A. DESCRIPTION OF THE PROPOSED CHANGE

This proposed amendment will revise Technical Specification Figures 3.1-3 and 3.1-4. These figures provide regulating group Control Element Assembly (CEA) insertion limits. Figure 3.1-3 provides CEA insertion limits when the Core Operating Limit Supervisory System (COLSS) is in service and Figure 3.1-4 provides the insertion limits when COLSS is out of service. The following two changes are proposed:

This proposed amendment will revise Technical Specification Figure 3.2-1A. This figure provides azimuthal power tilt limits versus core power for COLSS in service. The azimuthal power tilt limit will be increased for operation below 40% of rated thermal power.

This proposed amendment will revise Technical Specification Figures 3.2-2 and 3.2-2A. These figures provide DNBR margin limits for various configurations of COLSS and CEACs inoperable. The changes are necessary to ensure that the Technical Specifications are consistent with the safety analyses performed for the Cycle 3 core design.

FIGURE 3.1 - 1A

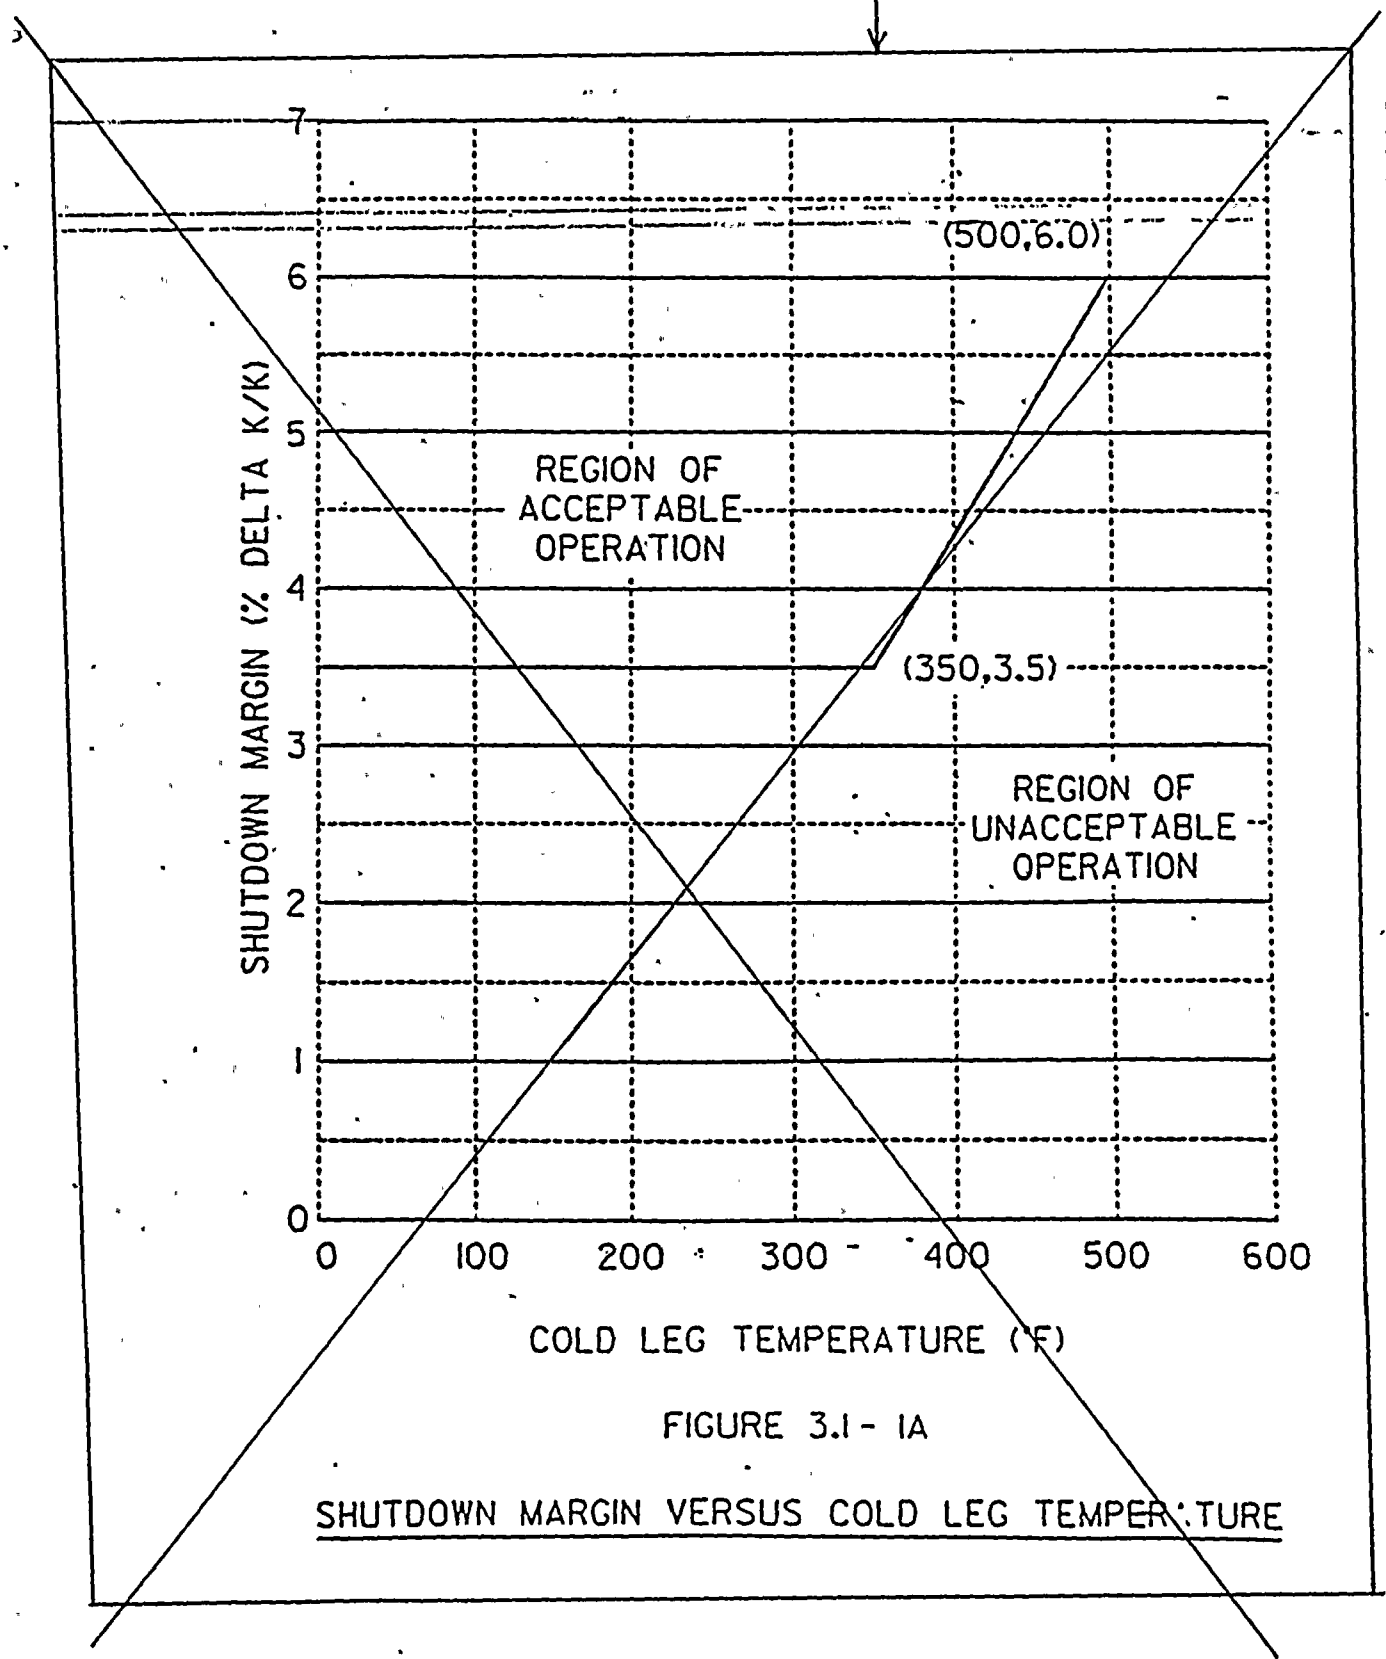
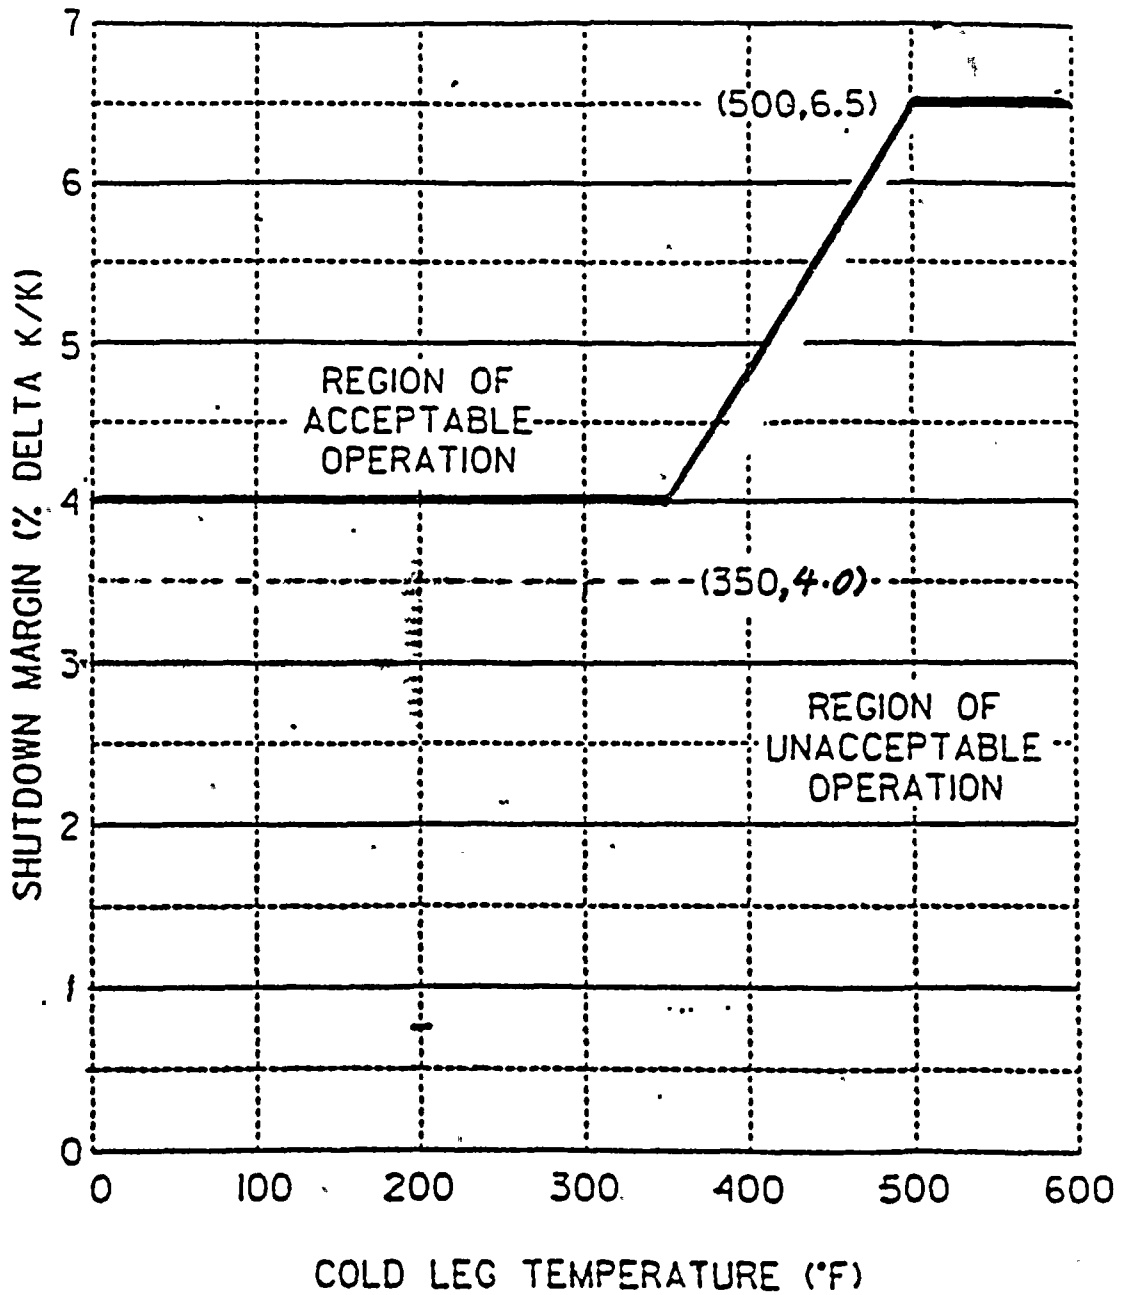
REPLACE WITH
NEW FIGURE 3.1-1A

REVISED
FIGURE
